SUBJECT: Triangle Expressway Southeast Extension (Complete 540) from NC 55

STIP Project Nos. R-2721, R-2828, and R-2829

Also, please reference your October 28, 2025, email, requesting modification of the permit to authorize change of impacts at Permit Sites 3, 5, 9, 12, and 13, for R-2829A. The modifications are necessary for in-field design revisions, including relocation of multiple utilities. The authorized additional impacts for this modification are as described below in Tables 1 & 2 below:

Action ID SAW-2009-02240; Complete 540; TIPS R-2721, R-2828, and R-2829

NC DEPARTMENT OF TRANSPORTATION DIVISION OF HIGHWAYS 9/4/2024 Wake County R-2829A SHEET

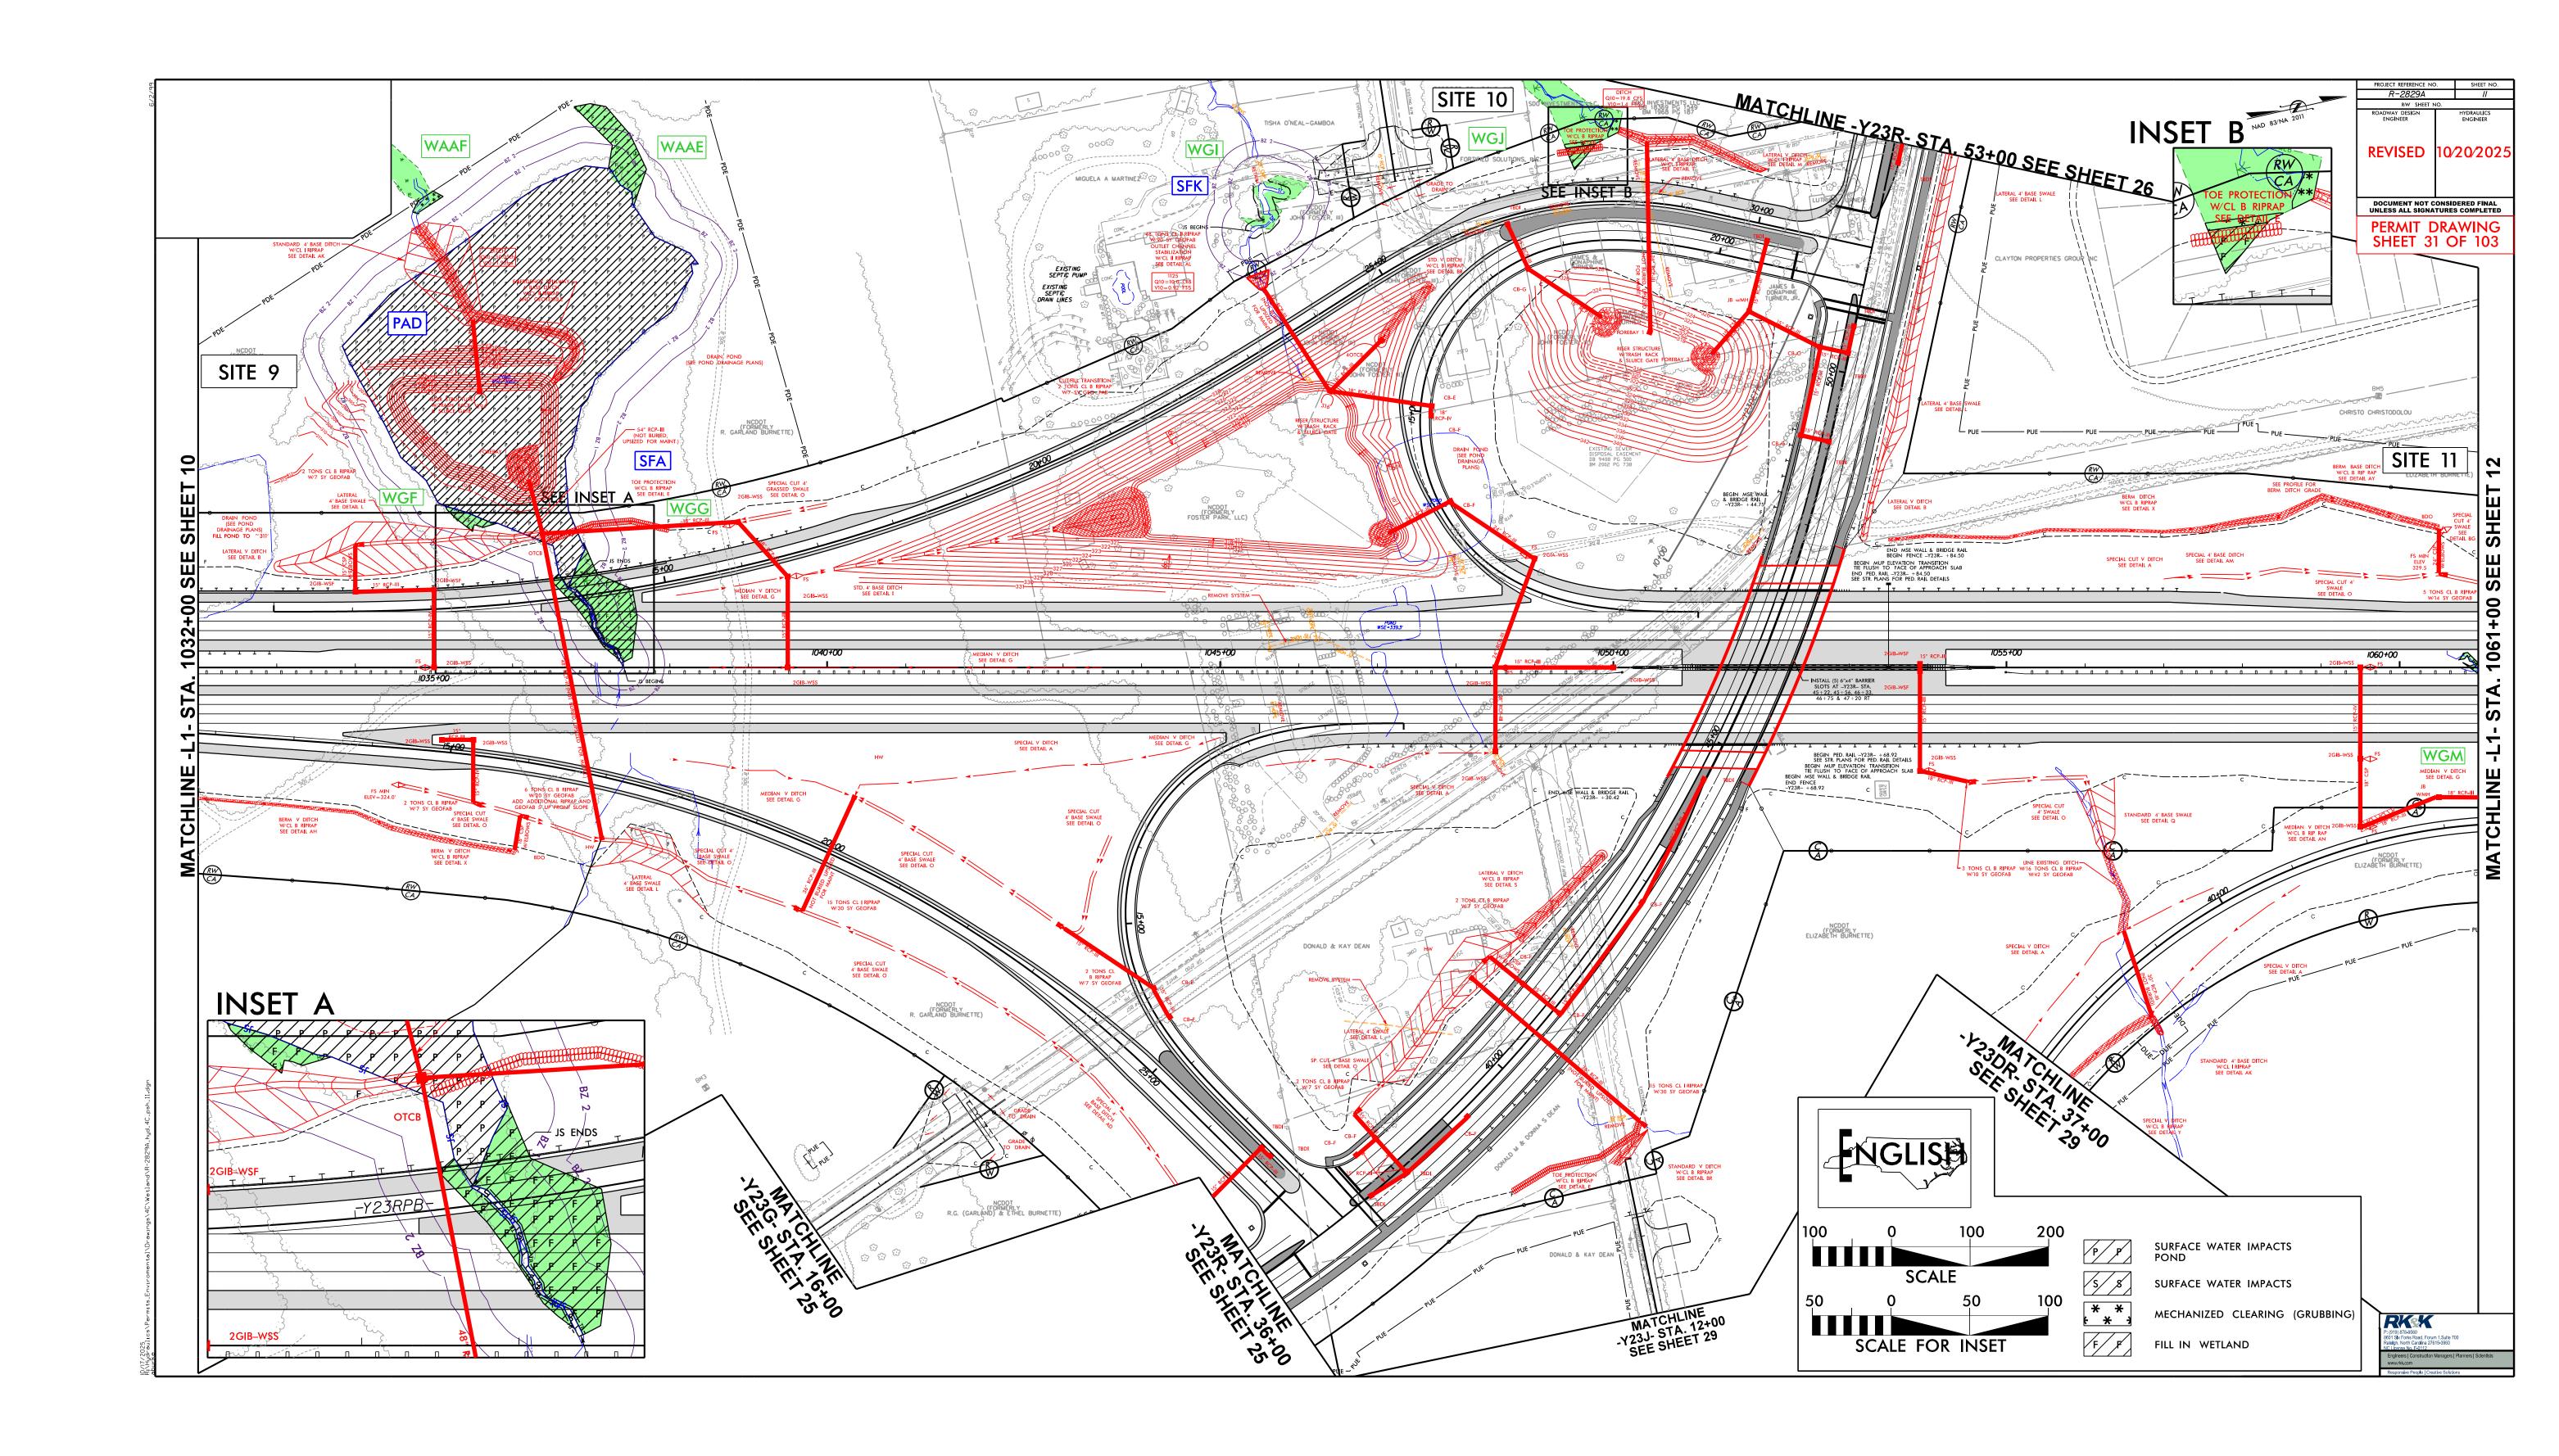
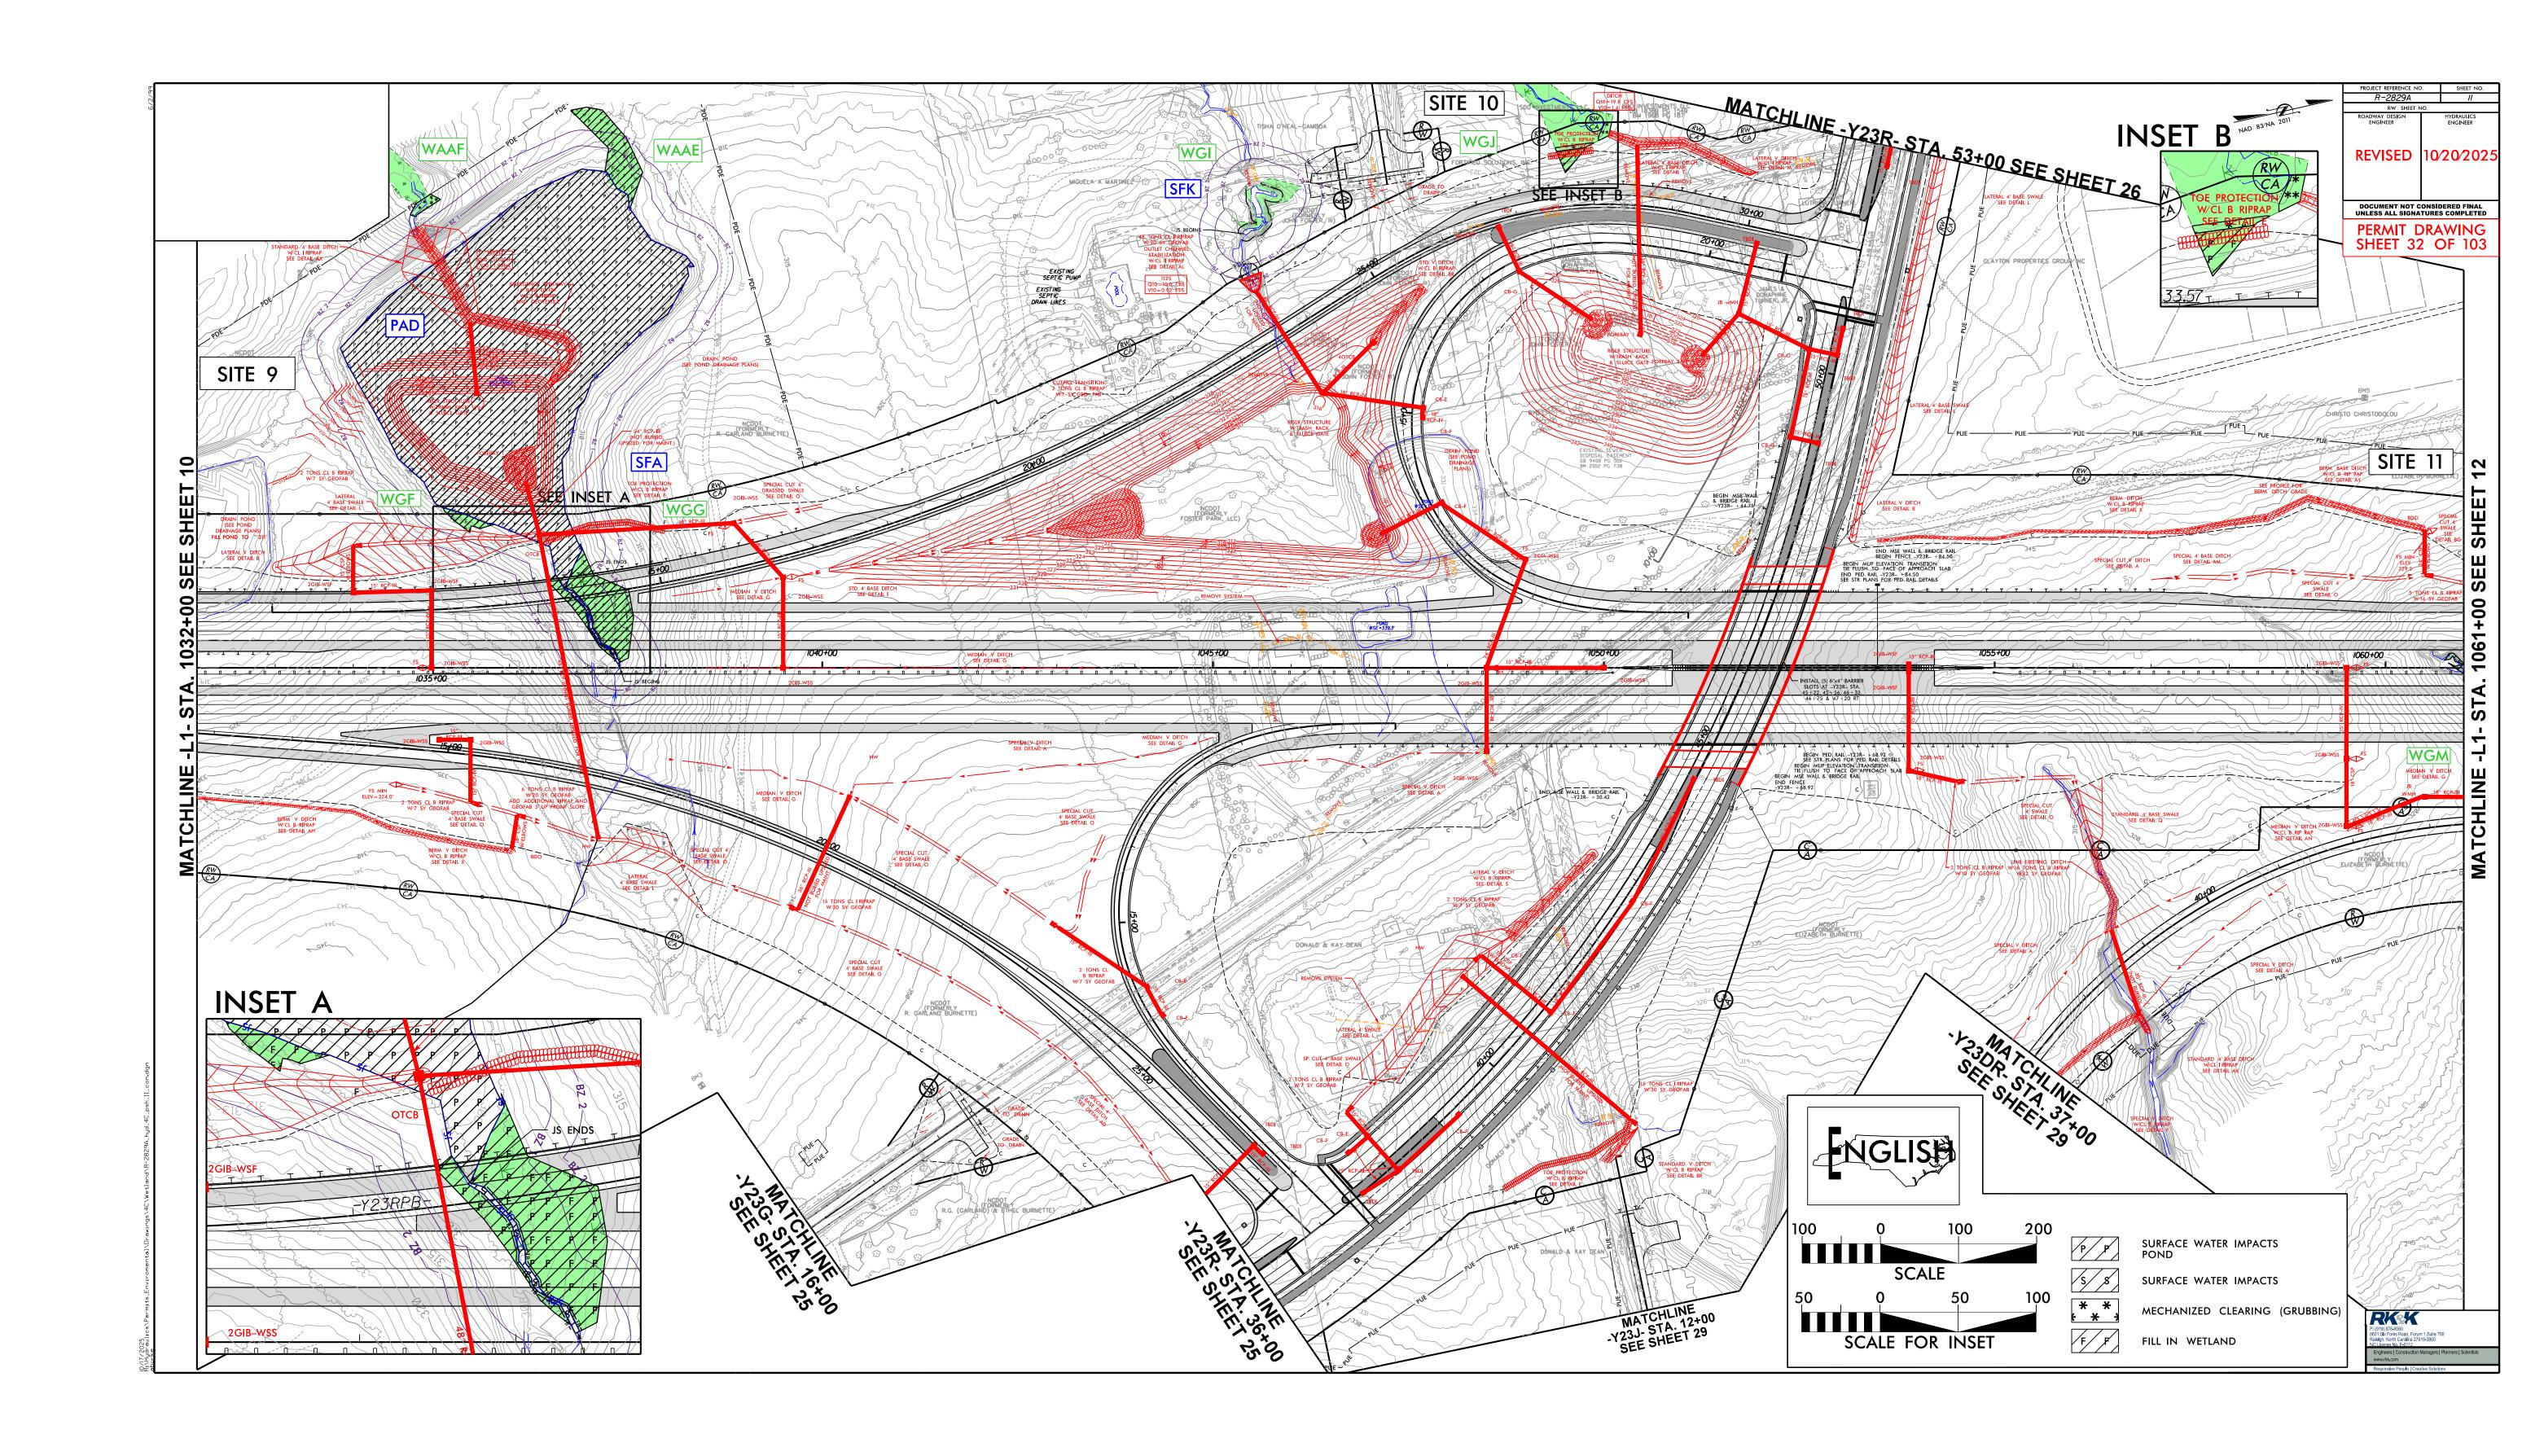
|             |                                     |                          |  | WETLAND IMPACTS                      |       |   |  |                                    | SURFACE WATER IMPACTS          |   |   |                                     |  |  |
|-------------|-------------------------------------|--------------------------|--|--------------------------------------|-------|---|--|------------------------------------|--------------------------------|---|---|-------------------------------------|--|--|
|             |                                     | WFN(1)                   | 0.284                                    | 0.049                                | 0.001 | 0.071   | 0.037                                      |                                    |                                |   |   |                                     |  |  |
|             |                                     | Bank Stabilization       |  |                                      |       |   |  | 0.002                              |                                | 25                                      |   |                                     |  |  |

Site 3: 4 interior bents with 4 @ 3.5' diameter columns per bent= total 154.4sq ft (0.004ac) permanent wetland impact (included above)

Revised 5/9/2025, 8/1/2025, **10/20/2025**
